**Charlie Parker/Abutters
Presentation to MVC
March 24, 2016**

Presentation Outline

Causeway: Lower Road Deck & Railing

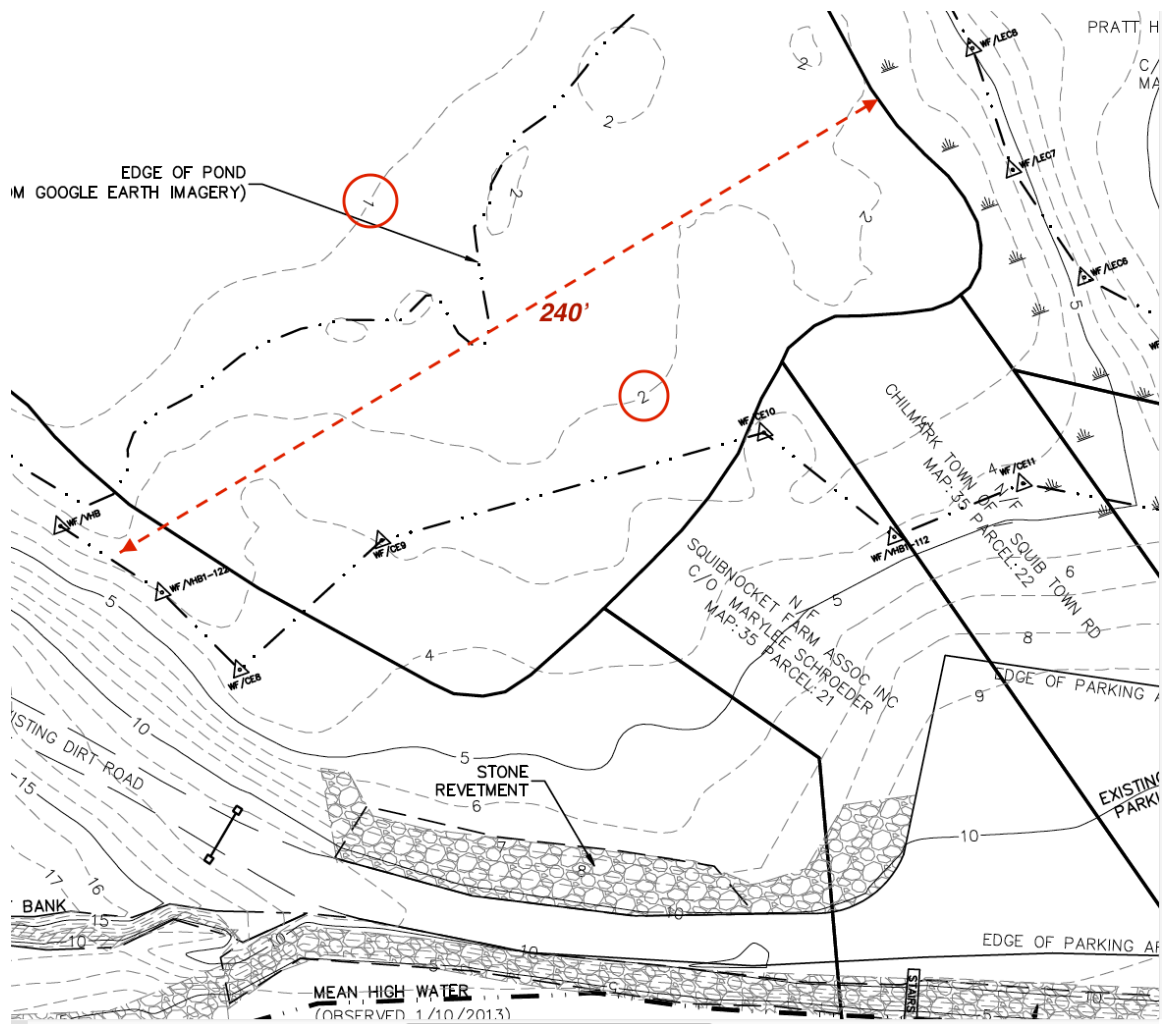
- Lower road deck by as much as 3'
- Lower guard rail from 4' to 2.5'

- More consistent with the rural character of the area
- Less obtrusive with less impact on abutters and beach goers

Shading

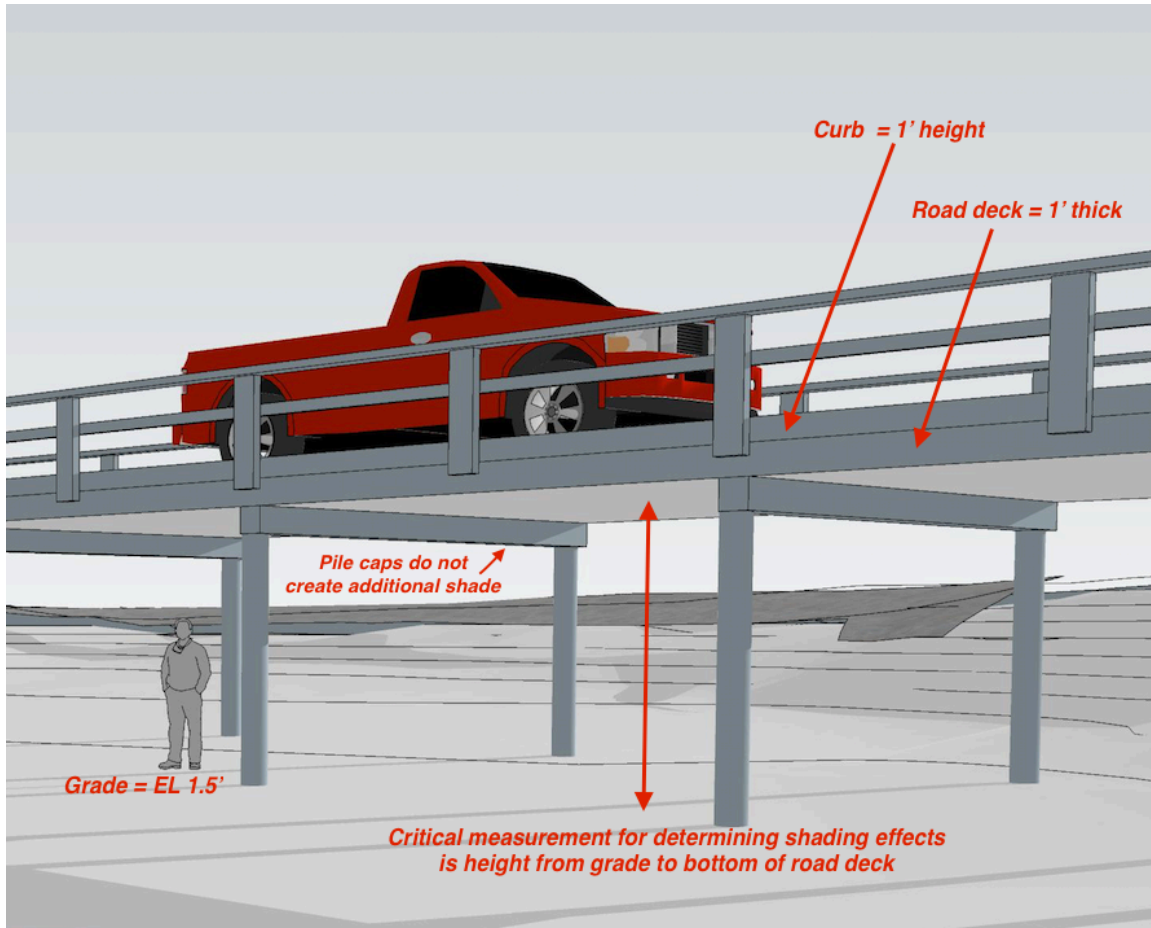
- Current proposal of 10.5' under the road deck is excessive
- 70% of causeway width from grade to bottom of road deck will mitigate shading effects:

'Bridges with height/width ratio greater than 0.7, did not have a measurable effect on primary and secondary productivity.' NC study 'Effects of Shading from Bridges on Estuarine Wetlands', June 2005, page iii.

- Key measurement is from grade to the bottom of the road deck
- Using the 70% ratio, 8.4' from grade to bottom of road deck is needed to mitigate shading effect
- This allows for a reduction of least 2' in height
- Conservative because bridge is oriented from north to south

Flooding/Hydraulics

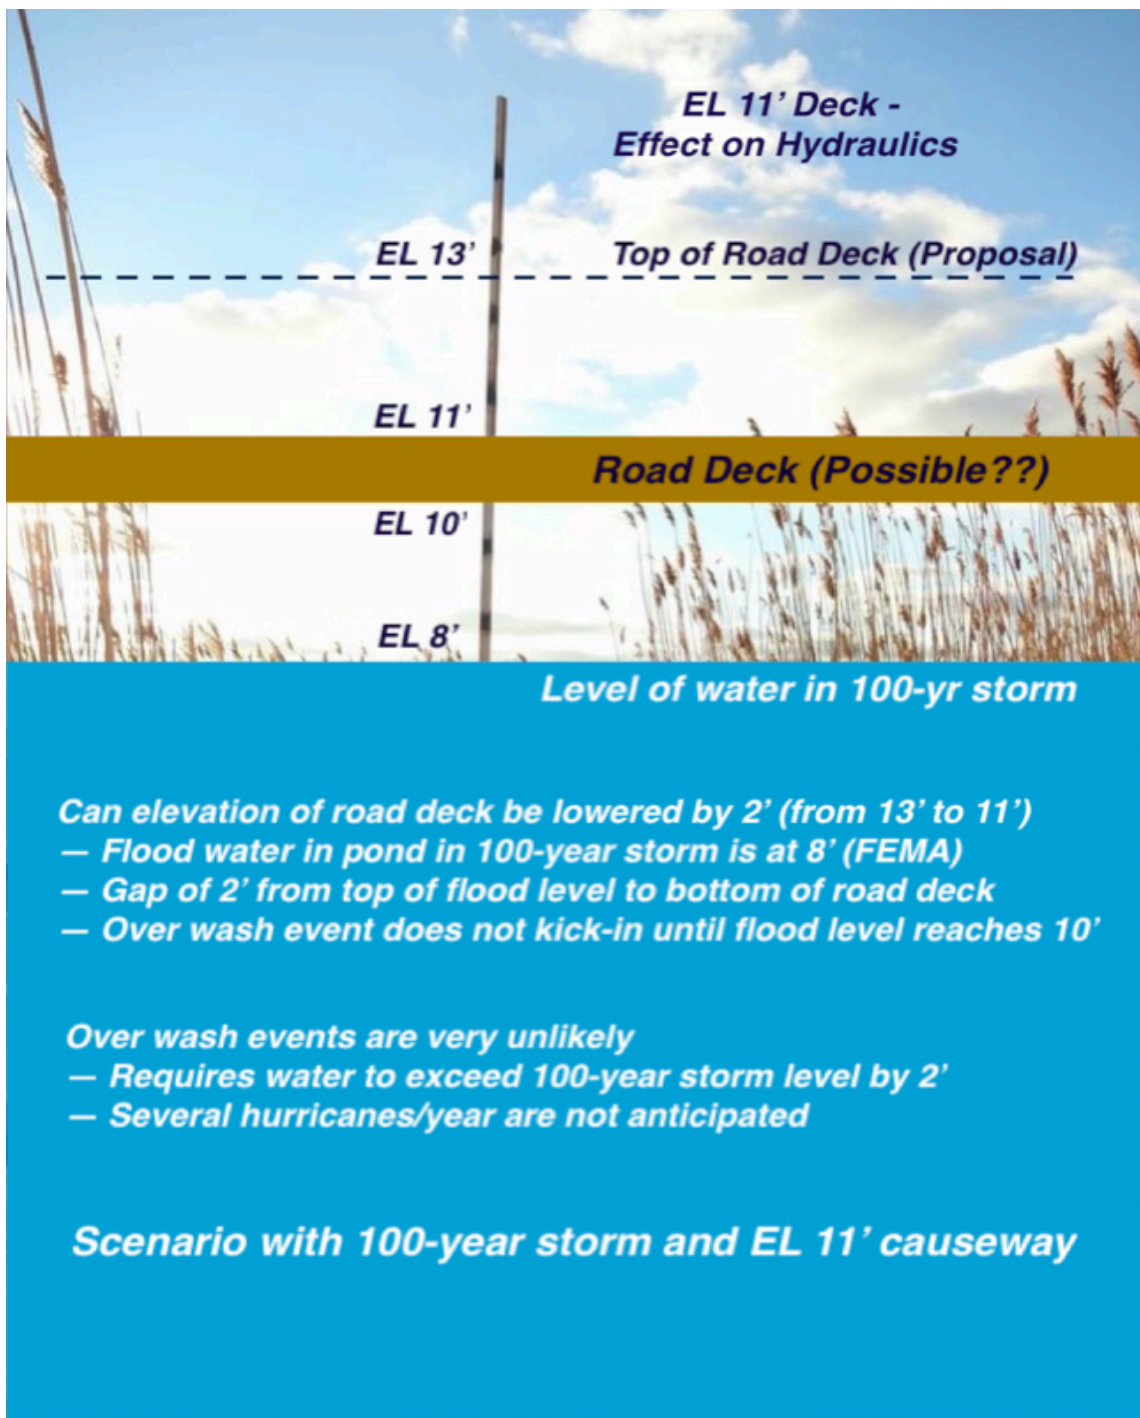
- Water level in pond has not exceeded 1.5' above current level since at least 1950 (records from Regen home)
- Center point of causeway is 180' from observed mean high water
- Western end-point is behind 19' glacial bank (Money Hill)

Causeway Railing

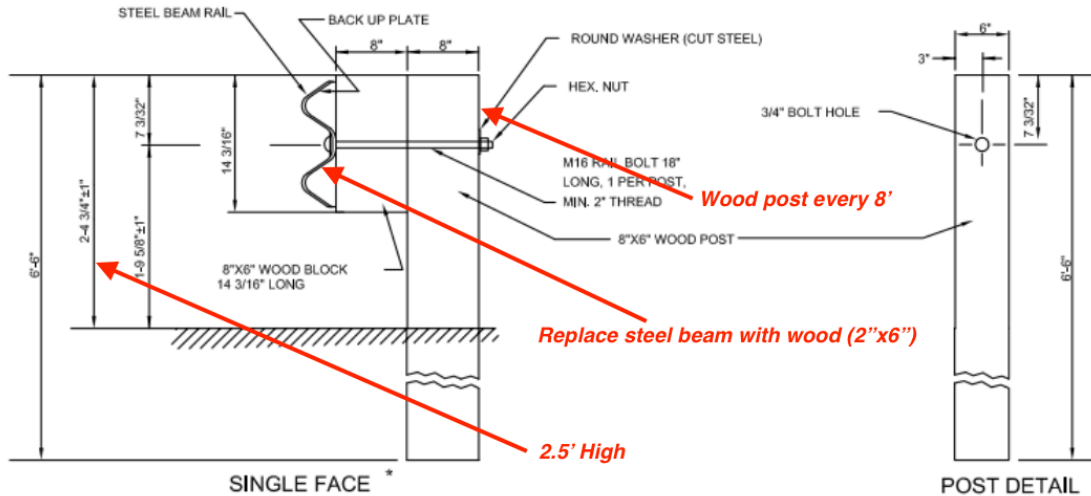
Railing on Menemsha causeway is lighter, more 'see through,' and less obtrusive.

STEEL BEAM HIGHWAY GUARD WITH WOOD POST

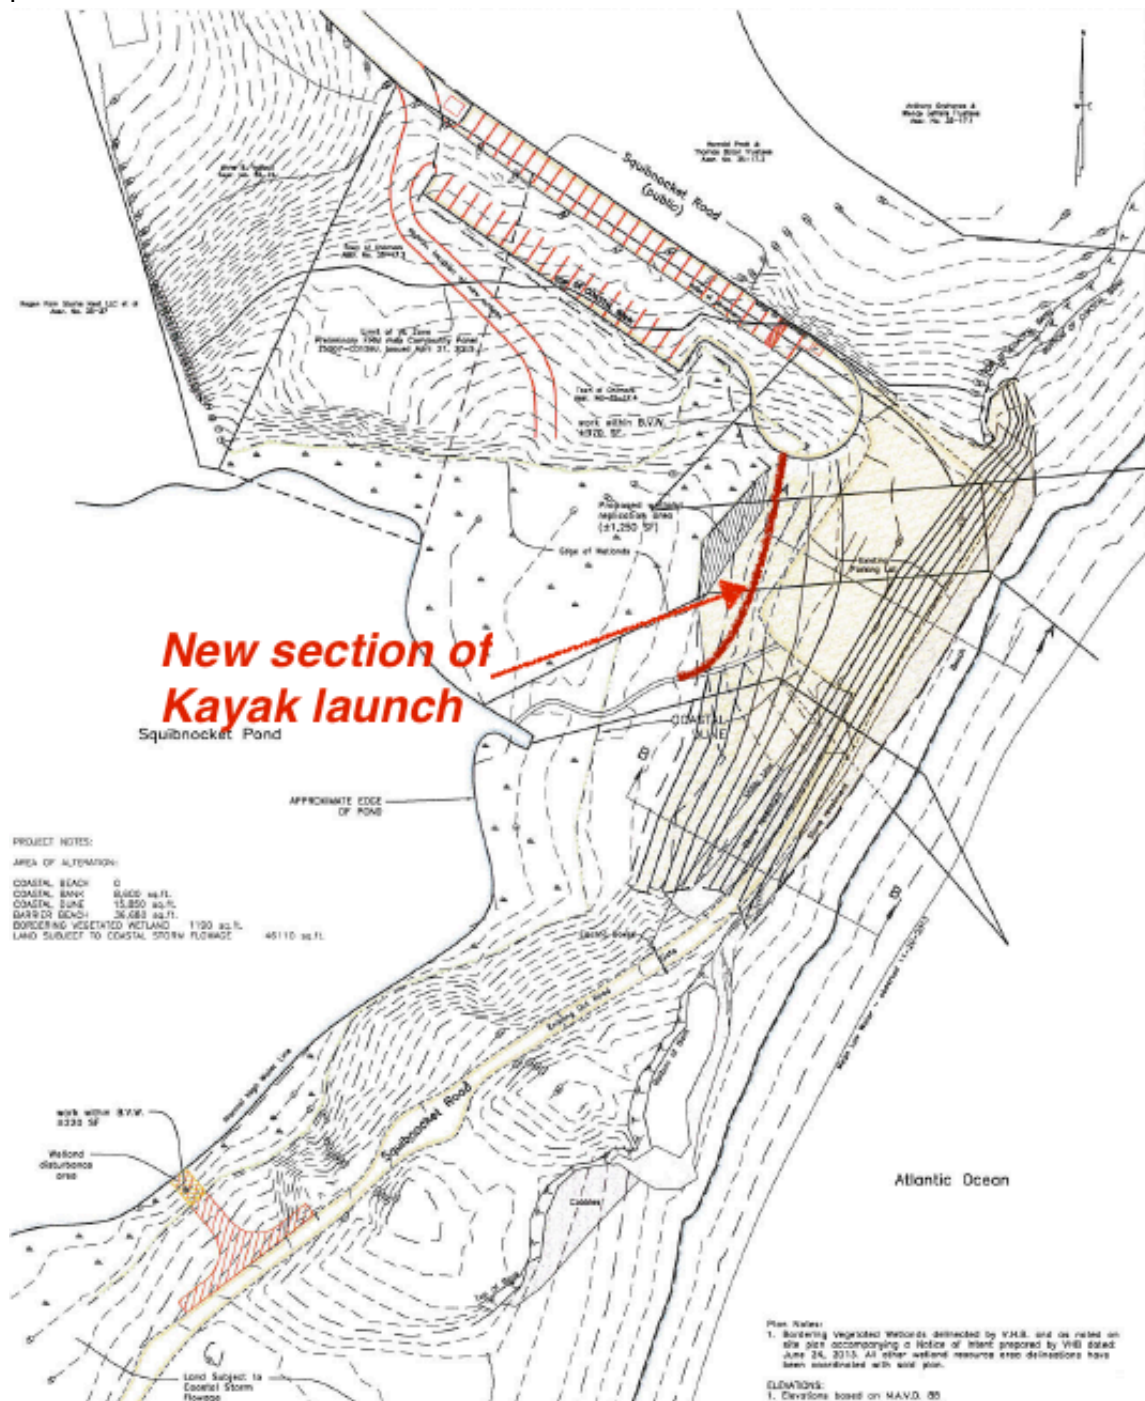
- Guard rail suitable for vehicular traffic on country road
- 15 mph speed limit
- 2.5' high, wood, posts 8' apart, 2x6 rail.

Skiff Launch

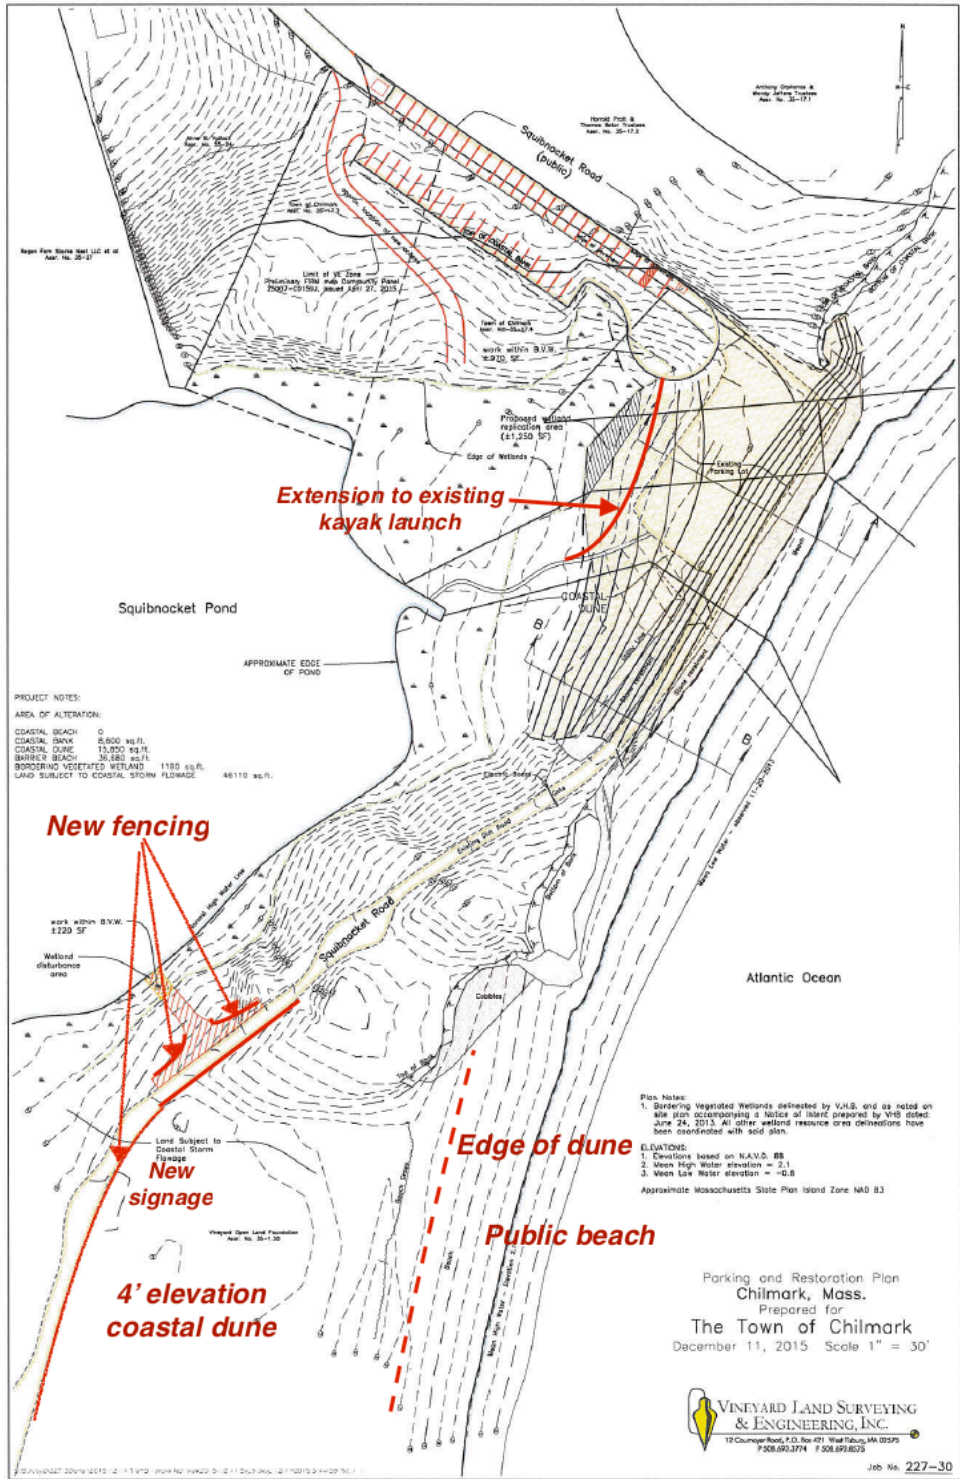
- Separate kayak launch from new skiff launch area
- Mitigation for effects of additional traffic from new skiff launch
 - 'Law of unintended consequences'

- New fencing to protect coastal bank next to skiff launch
- Gate for skiff launch (similar to Aquinnah)
- Signage to prohibit people from crossing coastal dune
- Simple rope fence at edge of dune by public beach
